DEVELOPMENT REVIEW COMMITTEE (DRC) COMMENT REPORT

PROJECT NAME: Hampton Inn - Fort Lauderdale

CASE NUMBER: R19070

REQUEST: Site Plan Level II Review: 84-Room Hotel

Exhibit 1 - FAÇADE and CORNER ACTIVTION

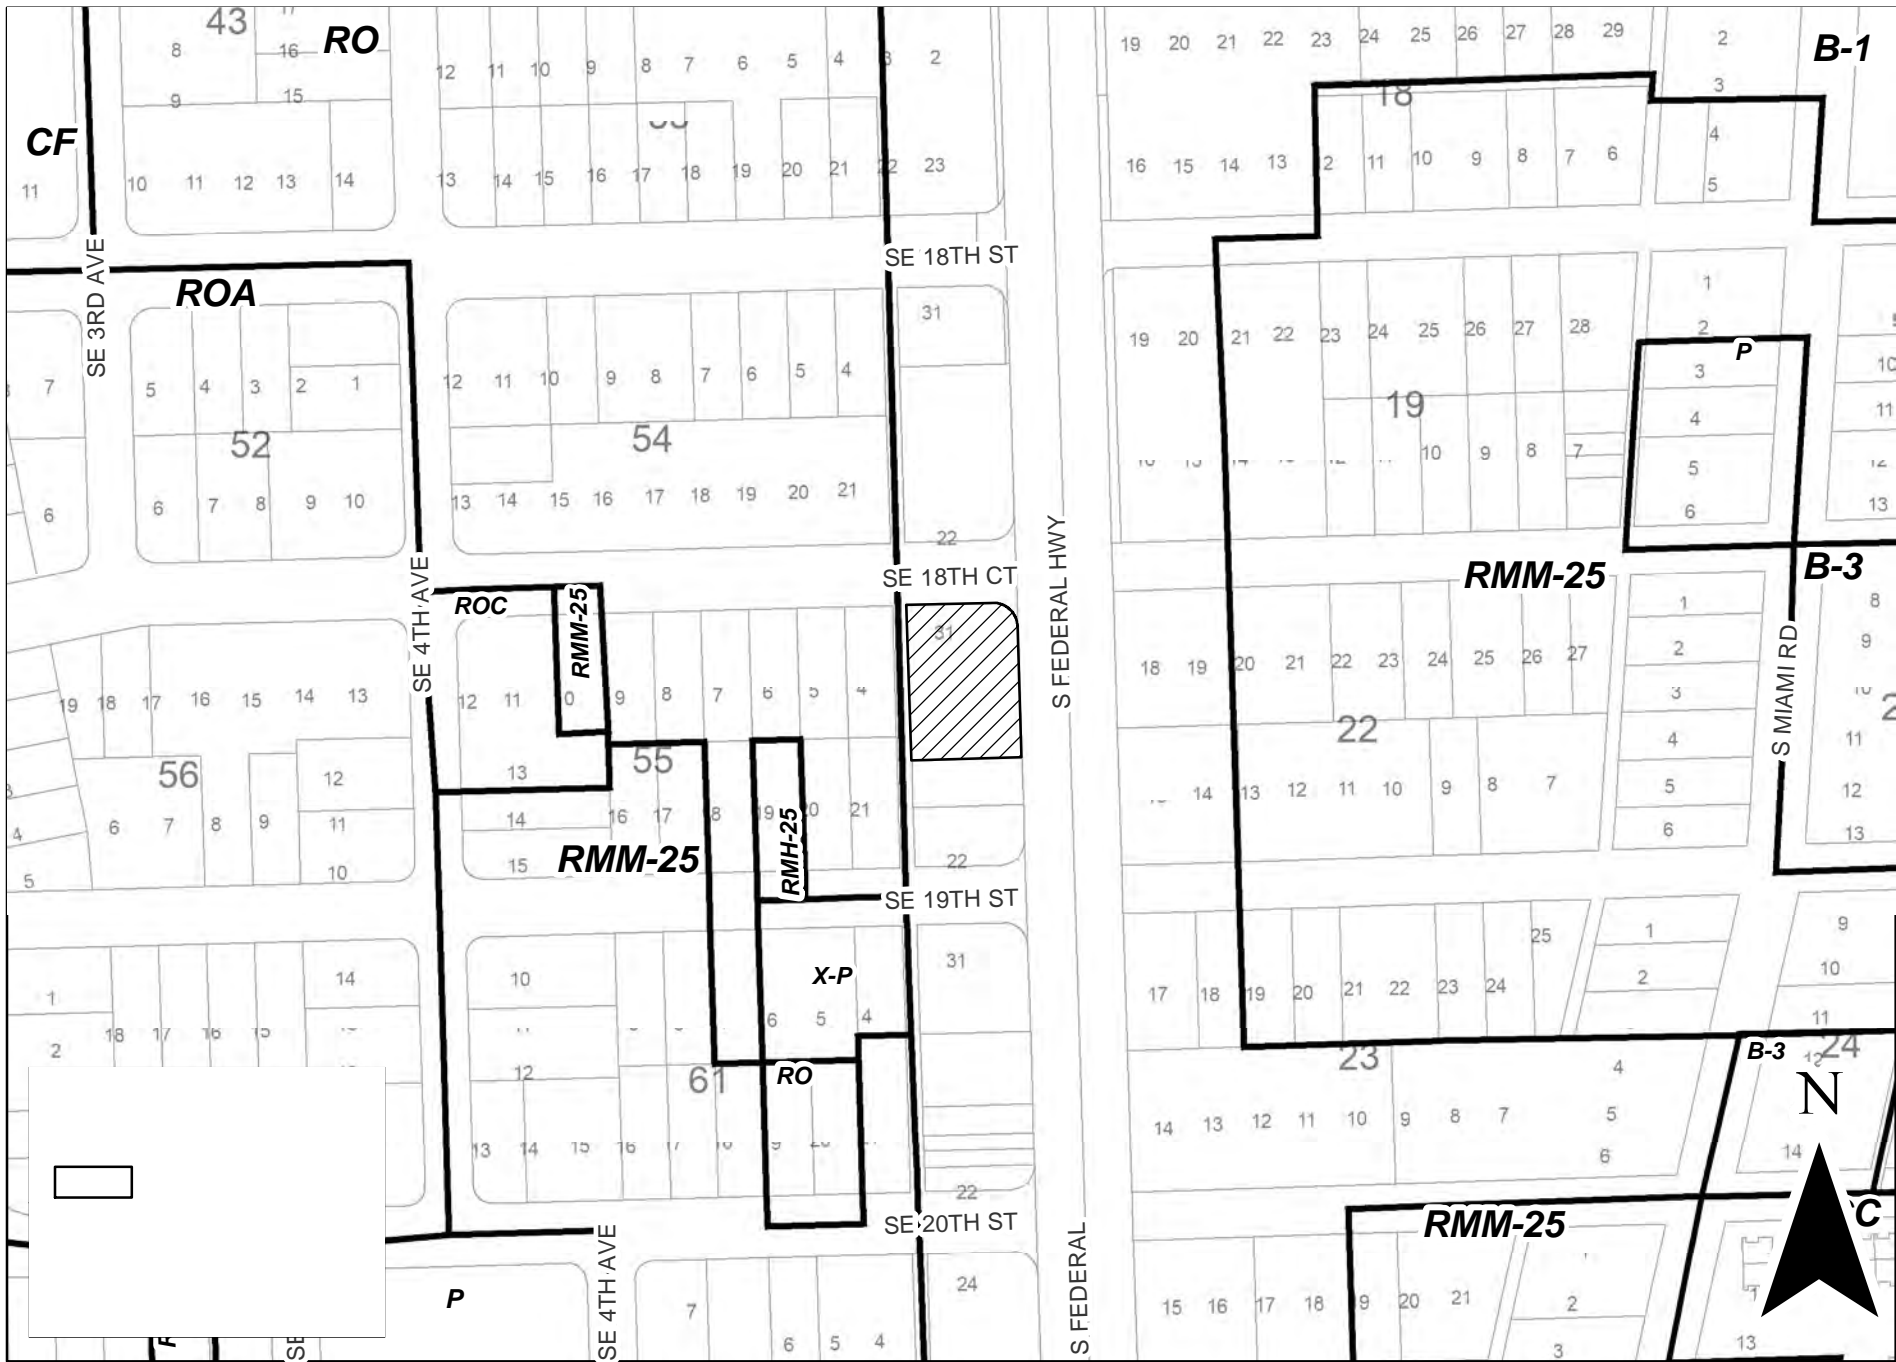
- i) Update the west façade to provide additional architectural elements that are compatible with the abutting residential area. Heavily consider reducing the buildings height and having the building step back further after the parking garage to reduce the visual impact of the structure on the residential properties. Note: screening and design should reduce vehicular sound and lights pollution.

- iii) The south elevation shows a flat blank wall. Provide fenestration and architectural elements such as banding, fenestration, and articulation to the south façade.
